DATE	DRAWN BY	REVISION	ISSUE	CUSTOMER SIGN	JOB REF
11/07/2022	AM	A	DA AMENDMENT		1349
			DESIGN DEVELOPMENT		
			CONSTRUCTION ISSUE

17 Old Sydney Road, Seaforth
Martin O'Conner

MOD2022/0302

FLOOR PLAN

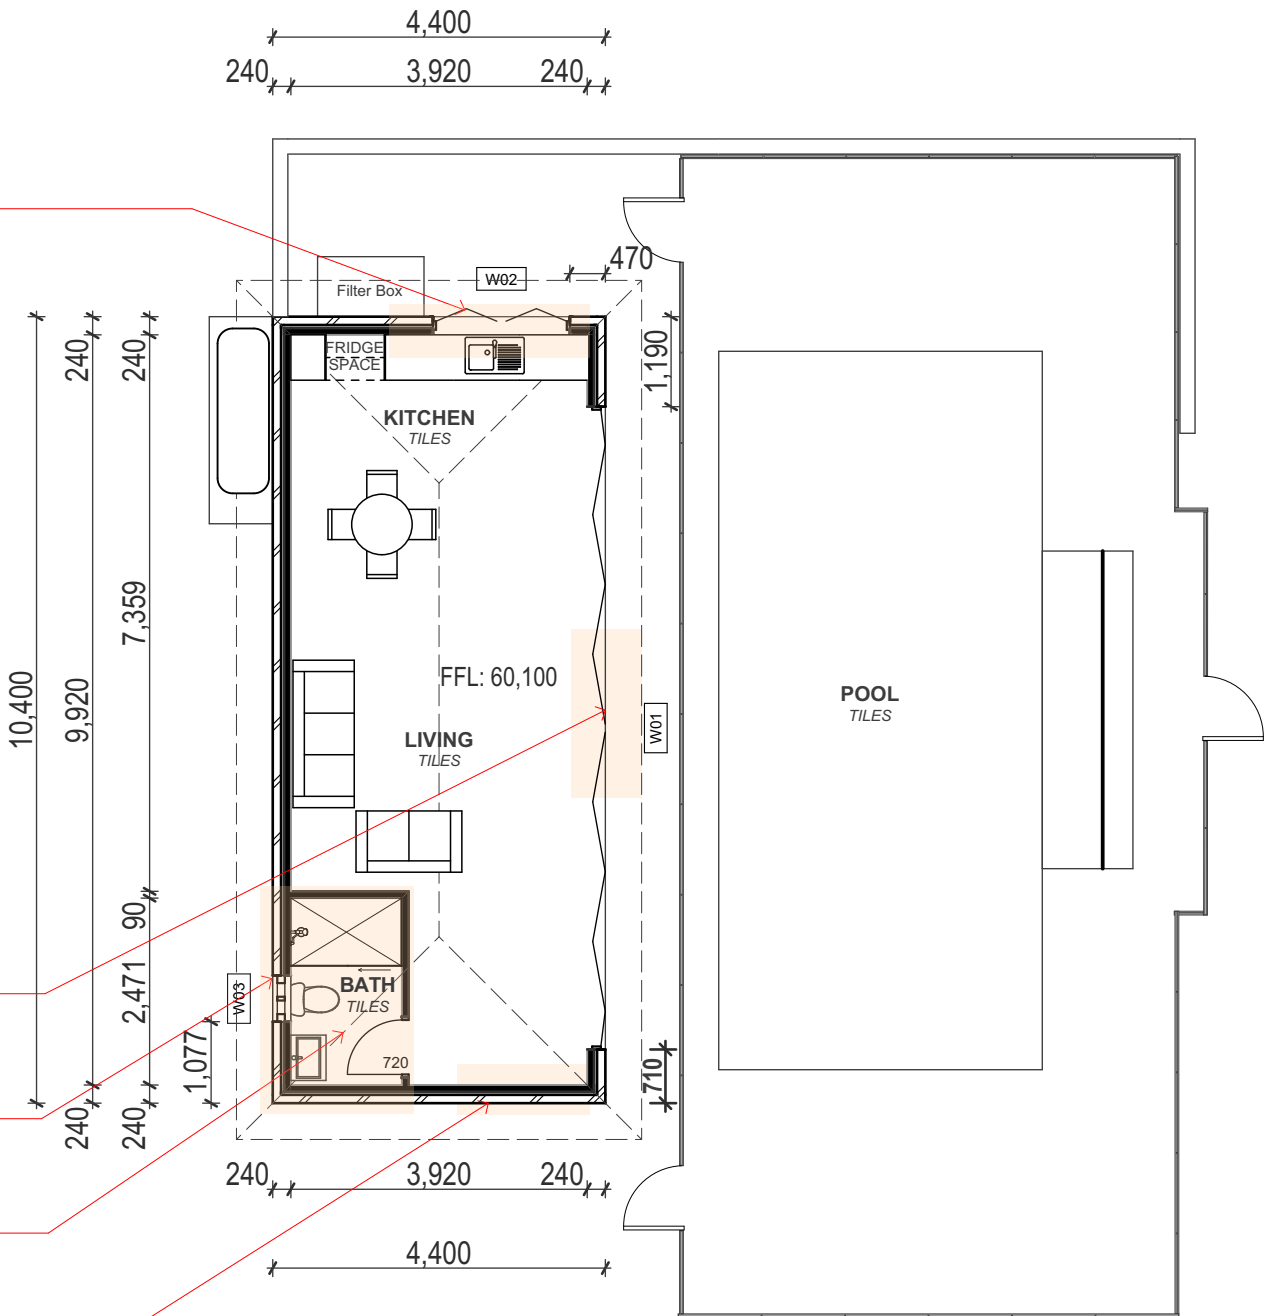
BIFOLD WINDOW MOVED TOWARDS FB
WIDTH CHANGED FROM
1370 mm TO 1810 mm (H 1029)

BI-FOLDING DOORS WILL HAVE
ITS TWO CENTER PANELS HINGED

BATHROOM WINDOW MOVED
TO THE MIDDLE

BATHROOM LAYOUT
CHANGED

DOOR REMOVED
